August 25, 2020

Project 20-2-1832-64-A.1

**RE:** Response to Email - Review of Previous Hydrogeological Work  
Poplar Woods Development - Phase 2  
Part of Lots 5 & 6, Concession 8 (Lobo), Ontario

**FIGURE 9**

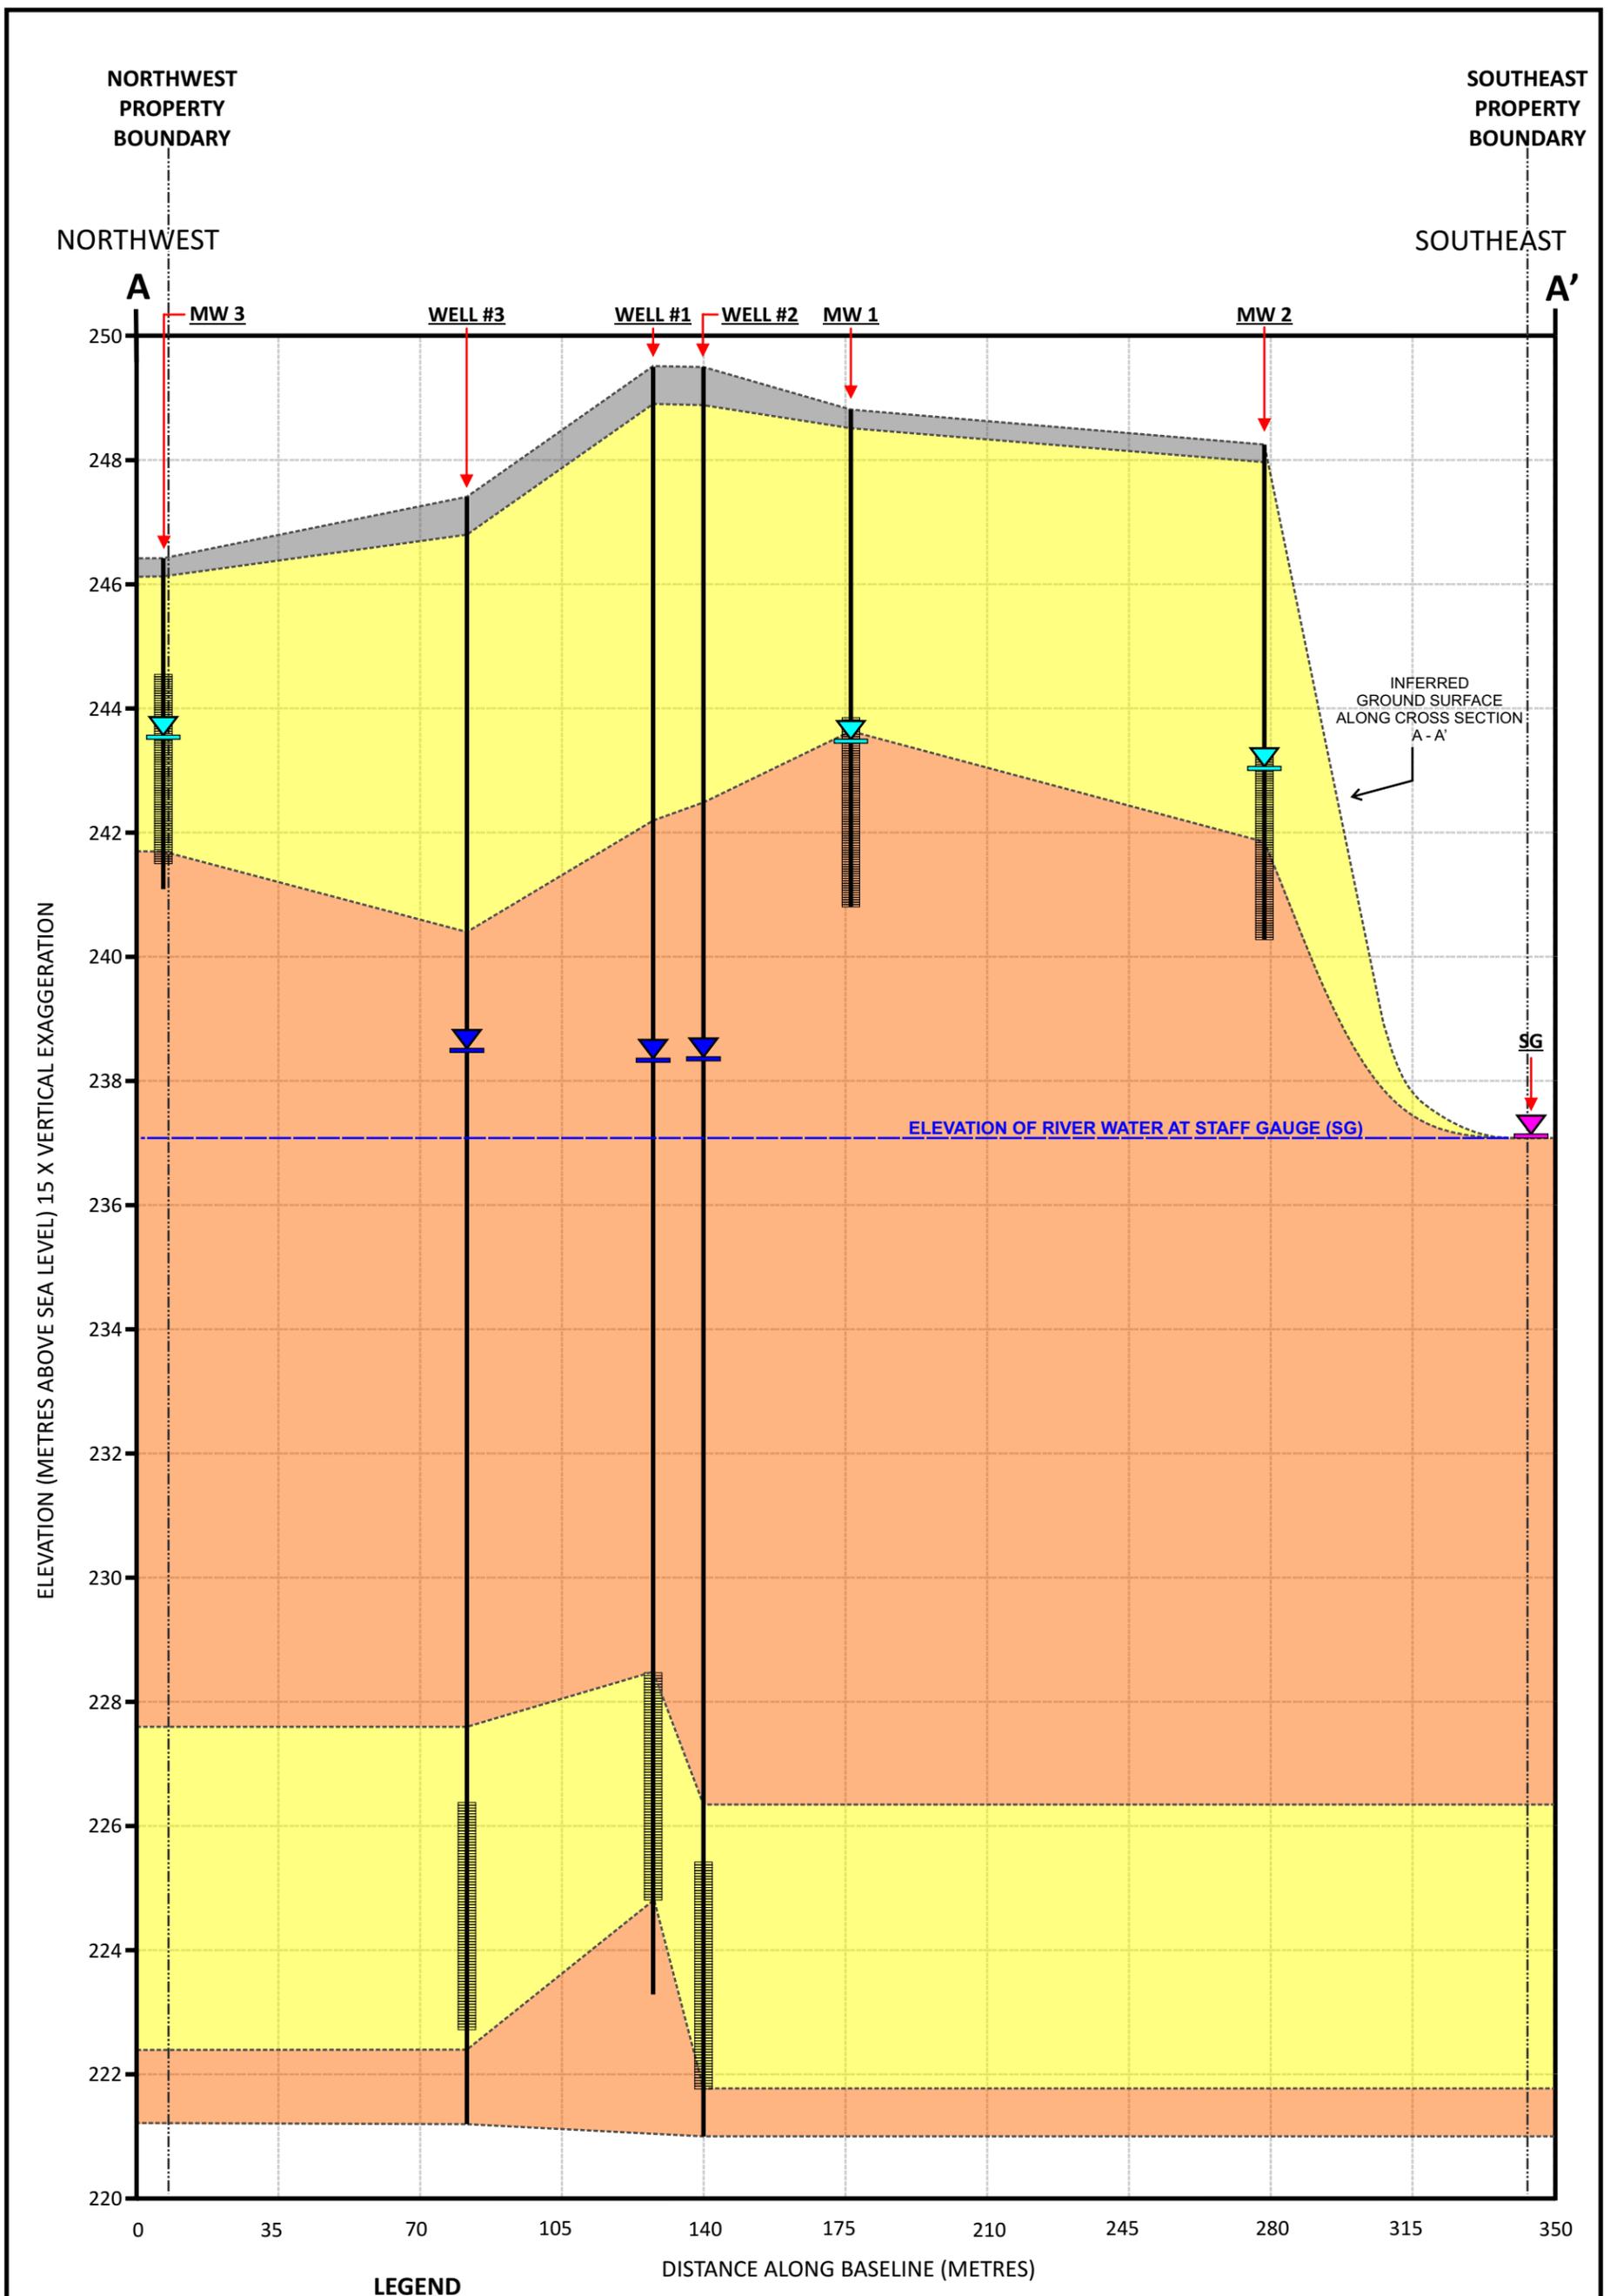
- 1) "The restriction of road salt within the development has been proposed as a mitigation measure in the JFM addendum dated April 20, 2018. Further details regarding the implementation within the plan of subdivision is required."; and,
- 2) "The Municipality must determine if the information provided to date is sufficient to address the potential risk associated with the provision of services with regards to the separation between the upper and lower aquifer."; and,
- 3) "The addendum report by JFM Environment, dated April 20, 2018 discusses the disposal of grey water, please confirm the report also addresses black water.

The report also addresses an issue with the installation of Well # 1, which has mixing between the upper and lower aquifer. The well construction should be repaired, as recommended by JFM Environment."

On Page 4, under the heading of Cross Contamination Between the Two Aquifers in the JFMEL Response, April 20, 2018 the following is noted. "Since 2015, the concentration of sodium in the shallow groundwater measured at MW1, MW2 and MW3 has substantially decreased. For example, in 2015, the sodium concentration at MW3, located next to Ilderton Road was 95,600 mg/L ; in 2017, the sodium concentration in the groundwater at that well was reported to be 73.6 mg/L. These concentrations suggest that between 2015 and 2017, the amount of road salt applied had dropped significantly. This assumes that the sodium concentration at MW3 are mostly from the application of road salt. MW3 is located near the roadside ditch which will convey stormwater that seeps into the ground and presumably into the shallow groundwater (upper aquifer)." Figure 9 shows well locations.

In the JFMEL January 15, 2018 report, the stratigraphy of the overburden of the Site was described based on water well records within 500 m of the Site from the Ministry of the Environment, Conservation and Parks (MECP), or at the time of the completion of the report, The Ministry of the Environment and Climate Change (MECC) database and from on-Site drilling of monitoring wells (stratigraphy logged by JFMEL personnel) and water wells (with stratigraphy as recorded by the water well drillers at the time of installation of the wells). For the JFMEL January 15, 2018 report, which is JFMEL's most recent hydrogeological report, 204 water well records were reviewed. The following descriptions of the Site stratigraphy and interpretation of the on-Site hydrogeology were included in this report. The interpreted stratigraphy is shown in the cross-sections, Figures 9A and 9B from Reference 3. Figure 9 shows the locations of the lines of cross-section in Plan view.
